Water Right Conditions Tracking Slip

FILE # # G-18012

PUBLIC INTEREST REVIEW FOR GROUNDWATER APPLICATIONS

SUBJECT: Application G- 18012 Supersedes review of 6/10/2015
Date of Review(s)

Prop 9999 and Rock Creek

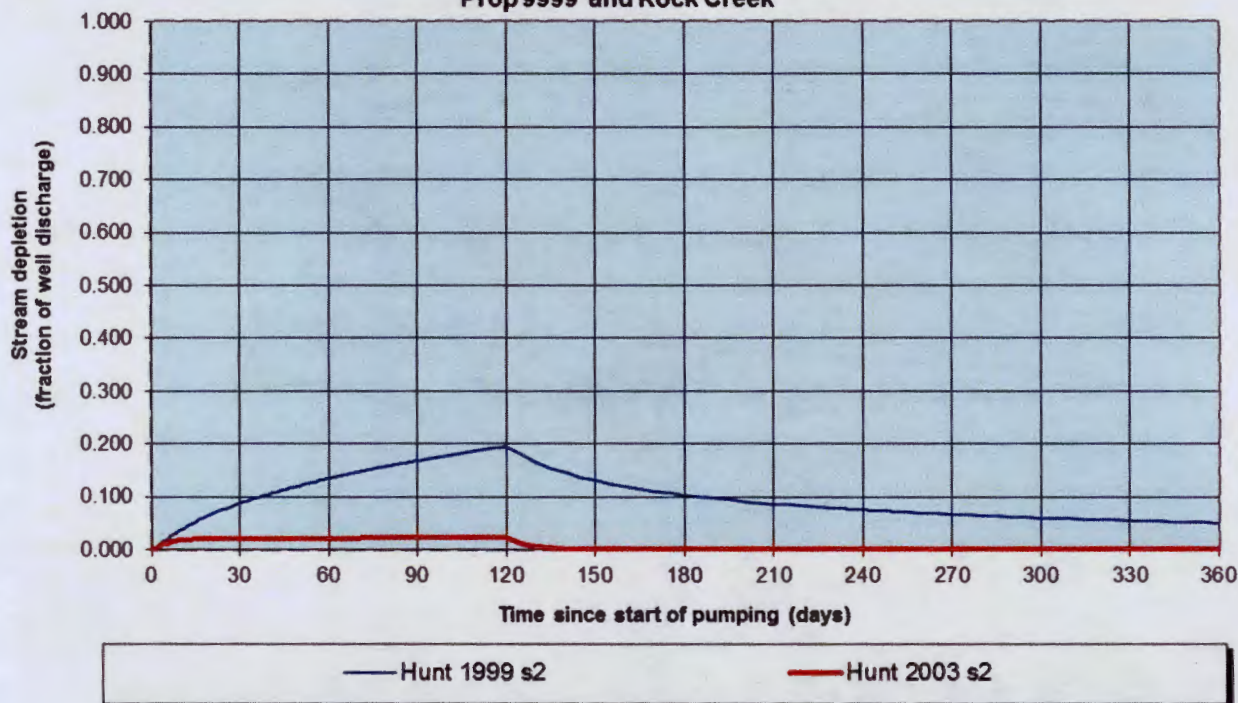
Comments: Stream depletion estimates using Hunt (2003) indicate interference at 30 days will be much less than 25% of the well discharge. See attached stream depletion estimates.
